INTERNAL MEMORANDUM

To: Kate Glover
From: Matt Davies (Ecologist)
Ext: 5278
Memo number: 3
Date of previous memo: 17/02/2026
Date: 01/04/2026

SUBJECT: P/25/0294 - The Norton, Penydarren New vehicular access, creation of 6 units in the Norton, construction of two dwellings and landscaping and parking area within site.

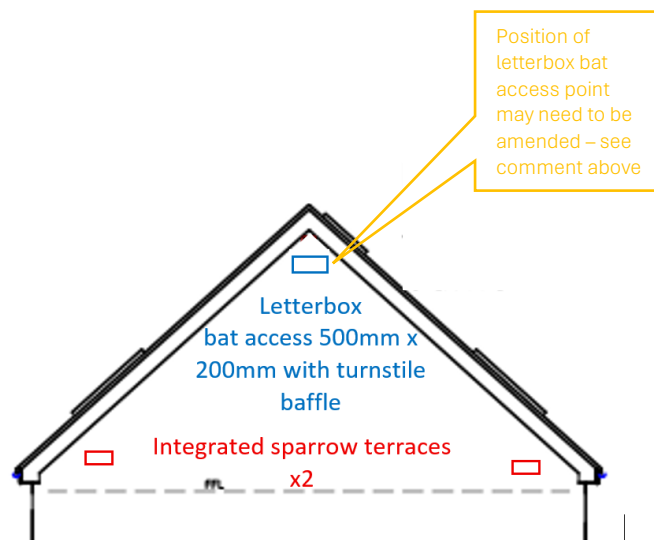
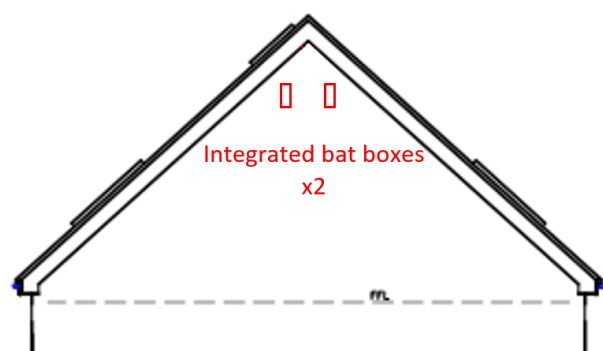
- Document 1 states there will be x2 integrated bat boxes and x2 integrated sparrow terraces built into the new properties, however, Document 2 only shows one of each.

Also, the sparrow terrace is shown too close to the letterbox style bat opening on the northeastern gable.

Please amend the drawings as below.

An additional bat box and an additional bird box have been added to the drawing, but the positions of the bird and bat features should be as shown above.
